Pier 2 Substation

Revised Column sizes.

Detail 1

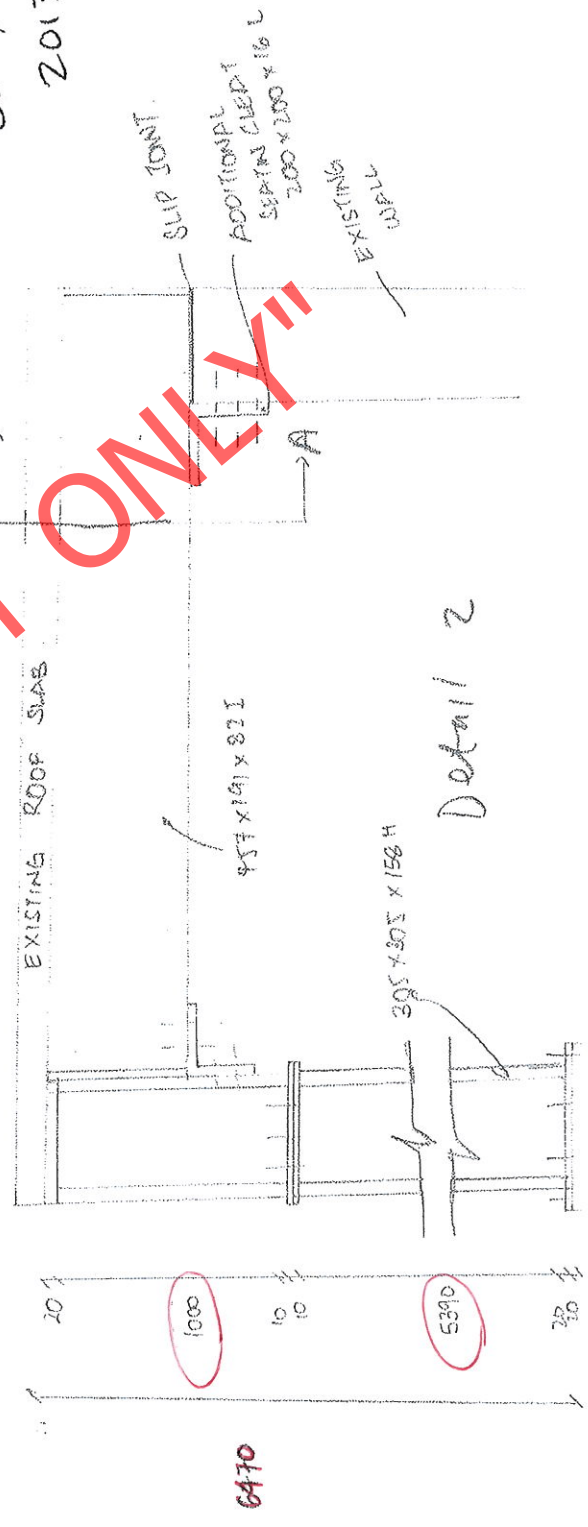
- Amend road to 305 x 305 H column position of joint (see detail 2 below)
- Repeat to add order 2 x additional angle sections (see detail 1) section A-A shows detail

GRADE S, & BOLTS 2 X Required.

200 x 200 x 16 L
